DSUP #2007-0004

**The Lofts at Del Ray Village
2707-2711 Mt Vernon Avenue**

Docket Item #11
DEVELOPMENT SPECIAL USE PERMIT #2007-0004
THE LOFTS AT DEL RAY VILLAGE

Planning Commission Meeting
May 1, 2007

Fig.2 : 3rd Level Expansion

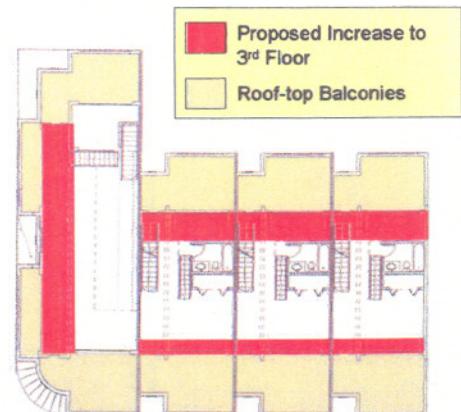
While staff is recommending approval of the proposed revisions to the Unit D and the ground floor uses, the minor revisions to the ground floor footprint and expansion of the third level, staff recommends that the size of the mezzanines and the height of the building be reduced as described in more

detail below. Additionally, staff does not support the full increase in the height or the mezzanines as proposed by the applicant, however the remaining elements of this proposal are consistent for this visually prominent location on Mount Vernon Avenue.

Fig.3 :Proposed Increase to Building & Balcony Heights

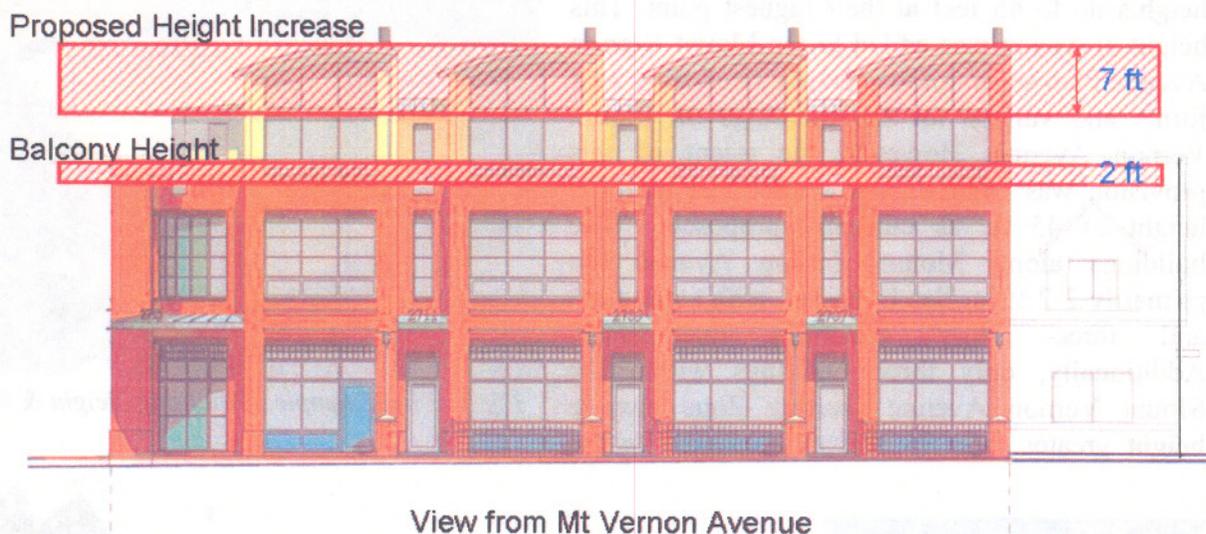
The applicant is proposing to increase the overall height of the building from 35 feet to approximately 42 feet in order to increase the floor to ceiling height on the ground floor and to add a fourth level mezzanine. The 7-foot increase in height has primarily resulted from the proposed mezzanine, which essentially results in a four level building. In addition to a 7-foot increase in height, the setback of the upper level has decreased from 16 to 12 ft. on Mount Vernon Avenue and from 16 to 11 ft. at rear of property.

Fig 4: Proposed Mezzanine Footprints and Third Floor Roofs

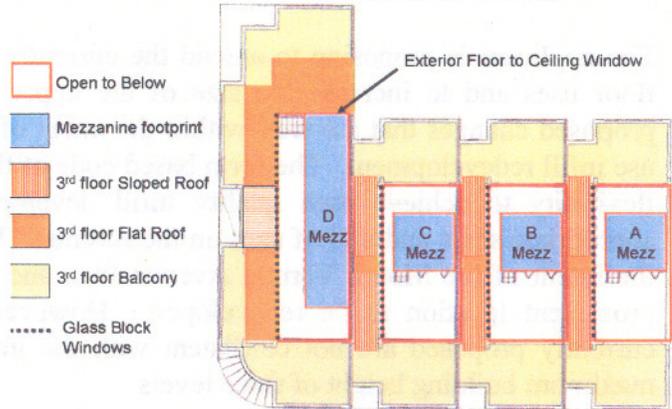
The Mount Vernon Avenue Plan states that a *maximum* of three stories is permitted with a required *minimum* 10-15 foot setback at the third floor, where compatible with existing scale. The intent of the Plan is to ensure that development reflects and is compatible with the existing smaller scale of Mount Vernon Avenue.

To address scale, the form based code requires upper level setbacks and a maximum height of three levels. The Plan does encourage a variety in roof forms and “loft-type” spaces with heights up to 45 feet at their highest point. This height provision was added to the Mount Vernon Avenue Plan so as not to preclude interesting roof forms and variety for the buildings on Mount Vernon Avenue. However, the intent of this provision was not to allow a continual building height of 45 ft. as currently proposed. The buildings along Mount Vernon Avenue are primarily 2-2 ½ stories in height, with some one- and three- story structures interspersed. Additionally, only three buildings within the Mount Vernon Avenue Overlay Zone have a height greater than 35 feet as measured to the

THIRD LEVEL EXPANSION

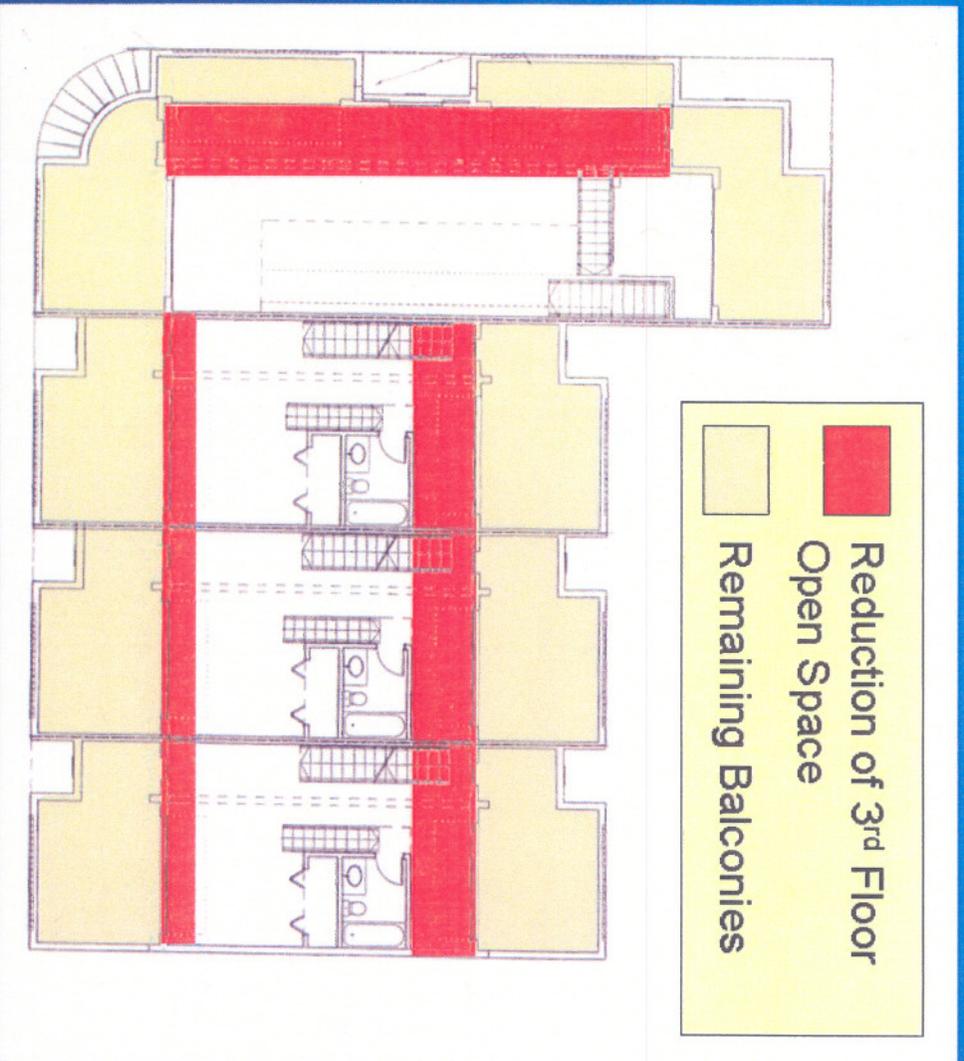
Increased from
2,343 s.f. to 2,890 s.f.
(approx. 547 s.f.)

MEZZANINE

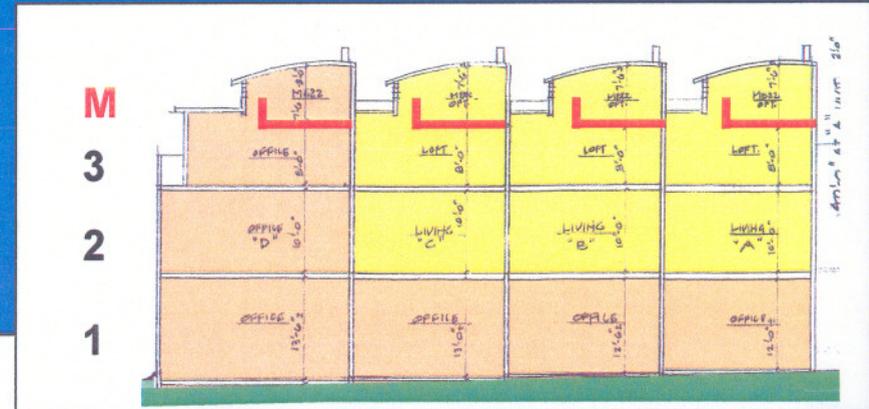
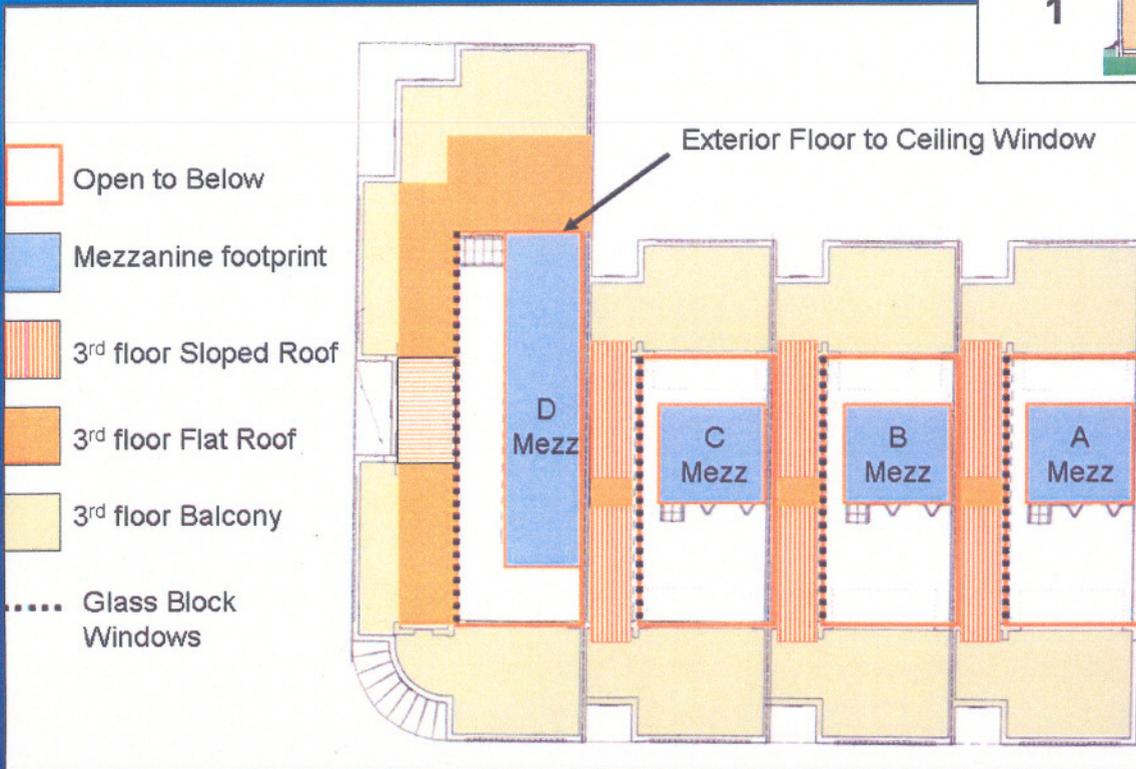
- 650 s.f. proposed
- Staff Recommends: 20% of roof form (approx 360 s.f.)

FOOTPRINT CHANGE

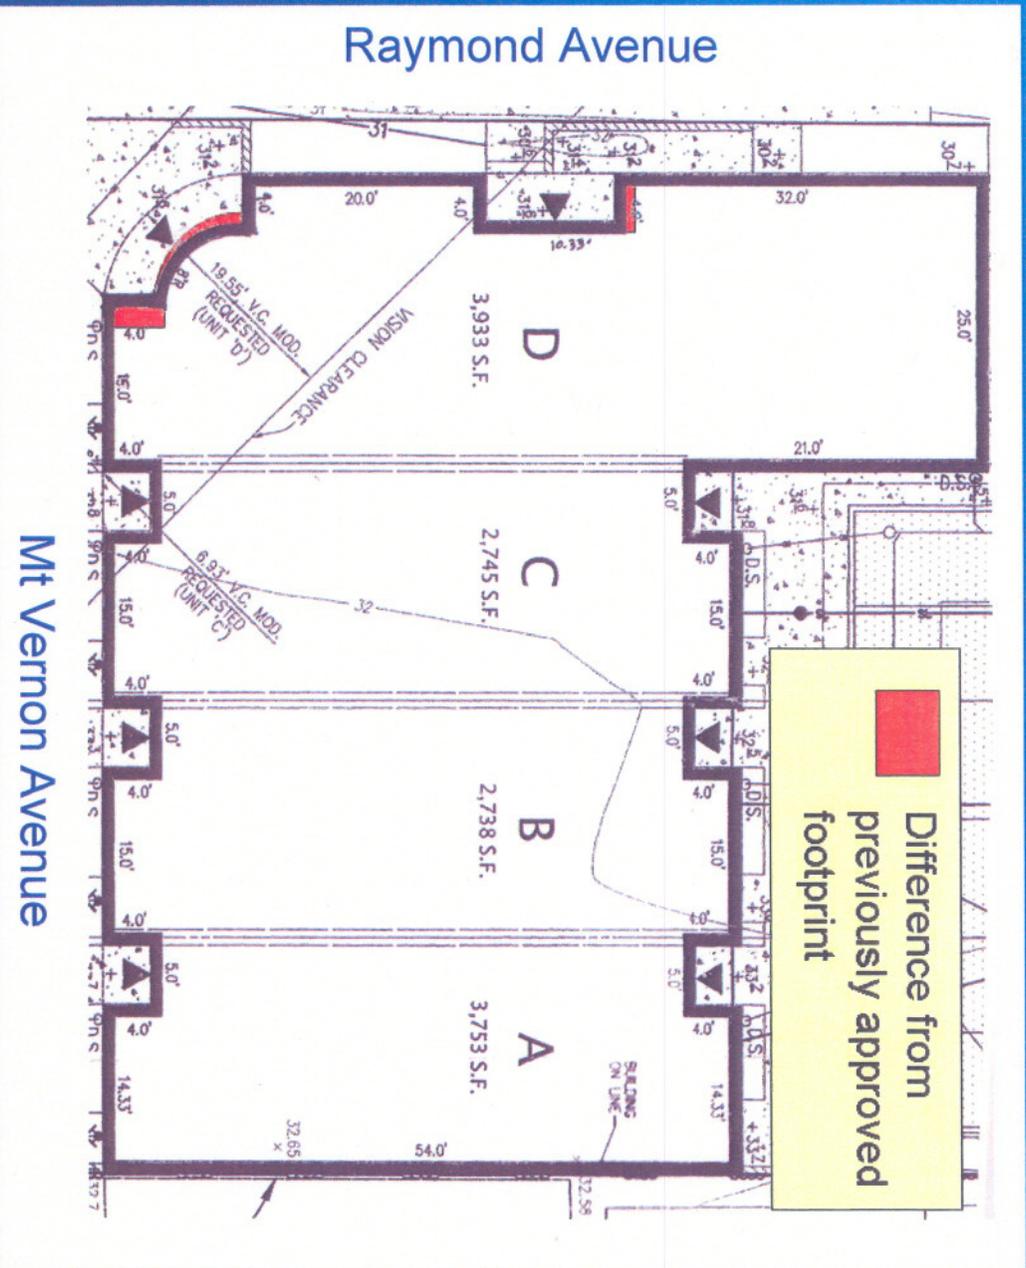
This amendment requests approval of an all office use for building D. The footprint of this building has been revised slightly to widen the front bay facing Mount Vernon Avenue from 13 feet to 15 feet wide thus matching the width of the bays on units A, B, and C. In addition the recess of the corner entry way has been deepened from 3 feet to 4 feet – again to match the 4 foot recess on all of the other bays and doorways.
